PLU #79
BOPCO, L.P.

ADMINISTRATIVE APPLICATION CHECKLIST

**Re: Notice of Application for
Authorization to Convert to SWD
Poker Lake Unit #79
Eddy County, New Mexico
File: 100-WF: PLU79.C108**

APPLICATION FOR AUTHORIZATION TO INJECT

LEASE: POKER LAKE UNIT WELL #: 79
 FIELD: CORRAL CANYON, NE (DELAWARE)
 LOCATION: 660' FSL & 660' FWL, SEC 2, T25S, R30E, UT.M
 COUNTY: EDDY ST: NM API: 30-015-27438

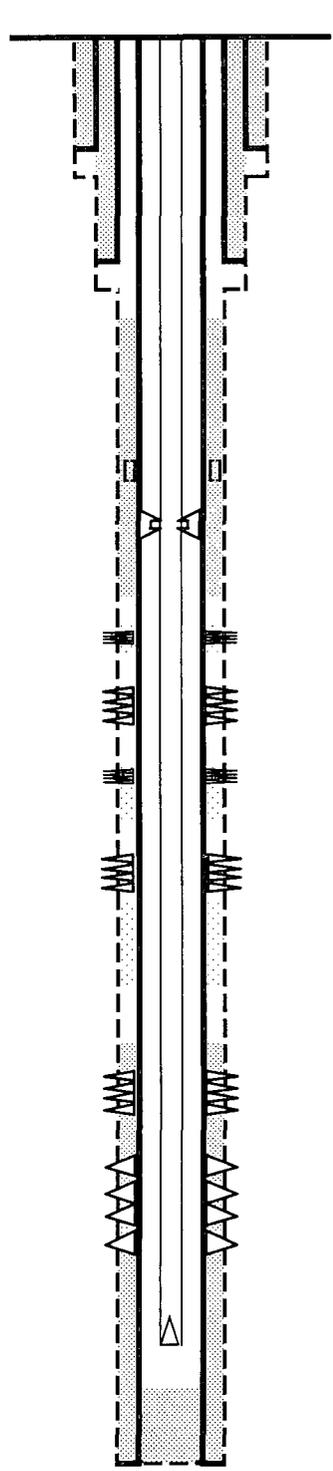
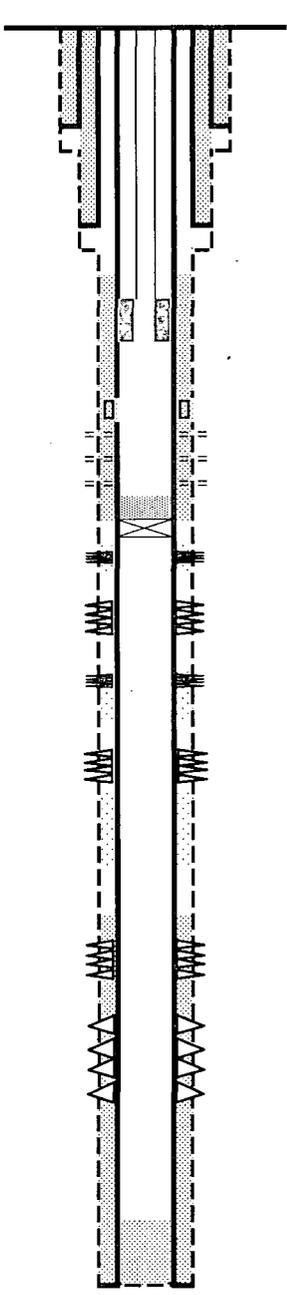
- a. The resulting permit will have three special conditions:
 - a. Set CIBP/Cmt at about 6000 feet to plug back the well over the former producing interval.

- b. Check bradenhead 8-5/8 – 5-1/2 inch for any problems – repair if anything shows up.
 - c. Reenter/Replug or Re-Enter/Convert to disposal offsetting well PLU #127 (Please send in the C-108 or Re-enter Sundry)

POKER LAKE UNIT #127

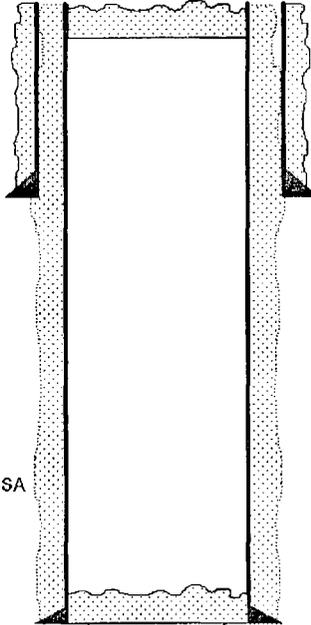
*Re-Plug
or Re-enter
& connect to DASH*

While reviewing the potential conversion to injection for the Poker Lake Unit #79, the BLM found that the Poker Lake Unit #127 could create some problems with the proposed injection. PLU #127 is 0.25 miles away from PLU#79 and is plugged, but the plugging is inadequate. The top of Bone Spring was missed and the plugs below the Lamar don't seem to be covering anything in particular. This could potentially allow the disposed water into one Delaware formation to potentially migrate into other Delaware producing formations or even into the Bone Spring formation.

Therefore, without remedial work on the PLU #127, the BLM objects to the conversion.

The plan on the PLU 127 is to drill out the current cmt plugs, set a cmt plug across the Bone Spring, run 7" flush csg (cemented to surface) down to ~6100 feet, and prepare the interval 4268' to 5928' for SWD. I will be using a 3-1/2" IPC tbg for injection. I correlated both logs to be sure that we would be disposing into the same correlative zone as that in the PLU 79. If you require a more detailed explanation of my plans please let me know and I'll be glad to send you all the necessary information.

We have talked to Wesley with the BLM. We will fix the PLU 127.
